**UNITED STATES DEPARTMENT OF COMMERCE  
Patent and Trademark Office**

08/902,331 07/29/97 GRUENENFELDER

## Office Action Summary

## **DETAILED ACTION**

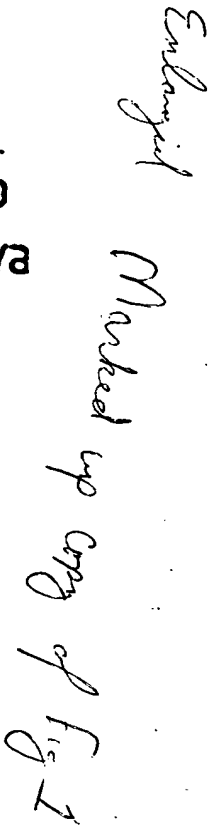
Furthermore Applicant indicates an equation wherein  $d_0 = d_{113} - a$  as shown in Fig. 1. Analysis of Fig. 1 does not show this relationship. First there is no clear disclosure of  $d_0$  in the drawing. Second and more notably, examination of the figure may not show this relationship. It appears that the upper surface of the target and lower limit of distance  $a$  are separated by a gap or

structure between the two components. The specification does not clearly set forth that the lower limit of distance  $a$  is directly adjacent to the upper surface of the target and Fig. 1, relied upon for this equation appears to show that the two components are not directly adjacent each other.

Therefore when determining the amount of taper the difference between  $d_{113}$  and  $a$  will give a value that is greater than  $d_0$  since it will also include the gap between the upper target surface and

a. For assistance in understanding the examiners position, an enlarged marked up copy of Fig. 1 is provided.

Appears that  
upper surface  
is not clear  
therefor,  $d_o = d_{us} - a$   
not defined
